Local Planning Panel

59-99 Belmont Street, Alexandria

D/2019/1249

proposal

3m setback to western boundary

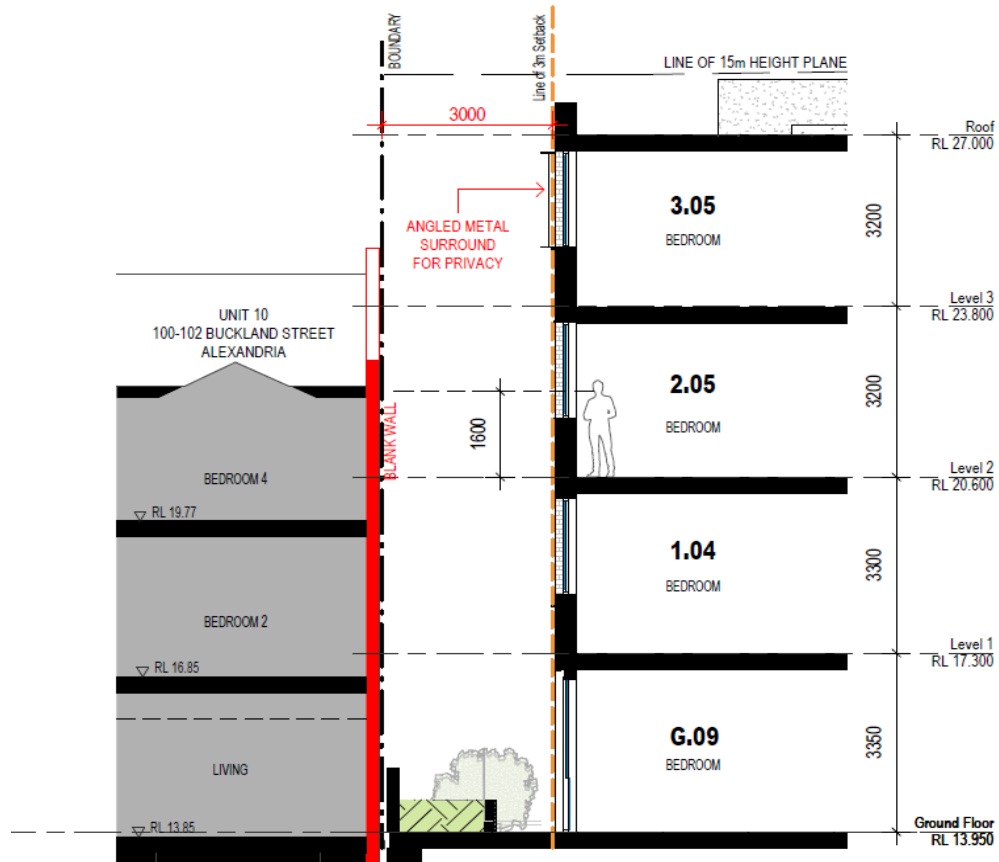
building generally aligns with blank wall condition and driveway

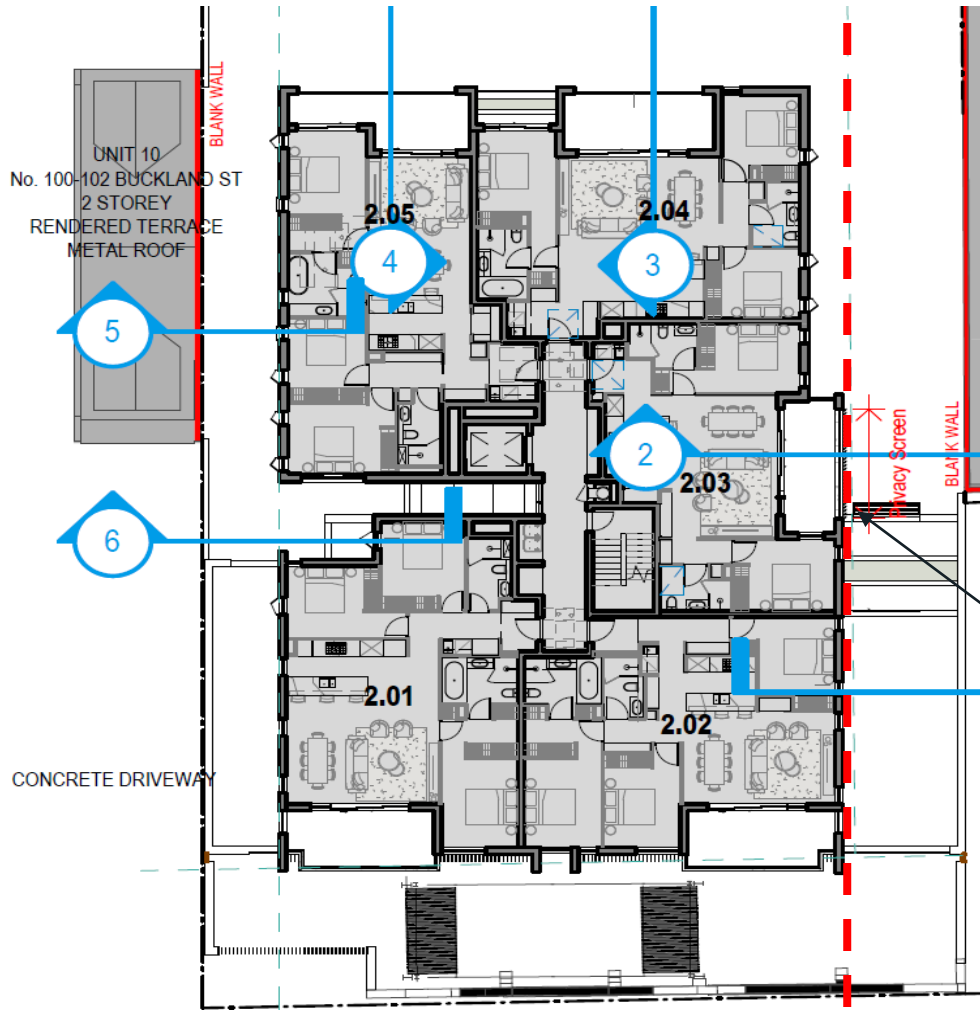
condition recommended
to turn window hoods
circled in red to face
Belmont Street (like
windows circled in green)

4.5m setback to eastern boundary

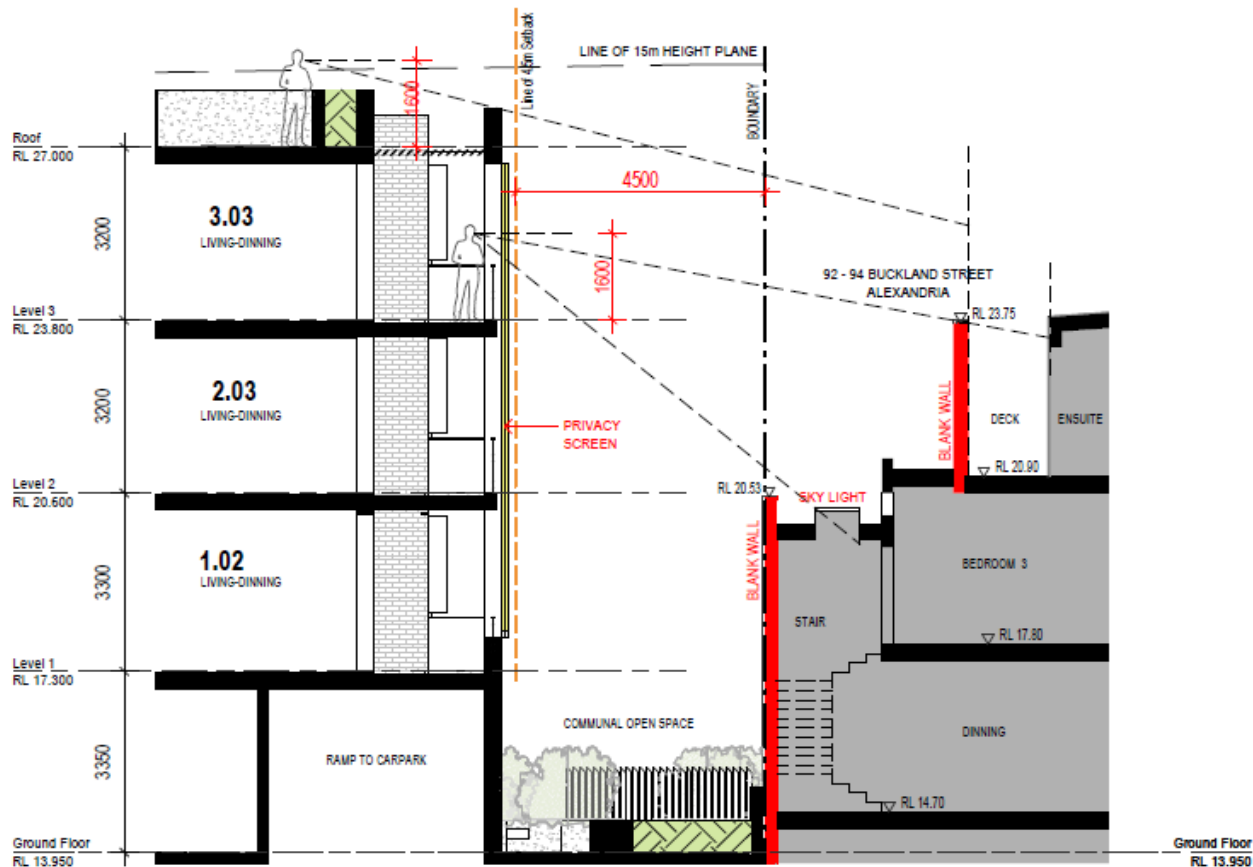
building generally aligns with blank wall conditions, and privacy screen provided
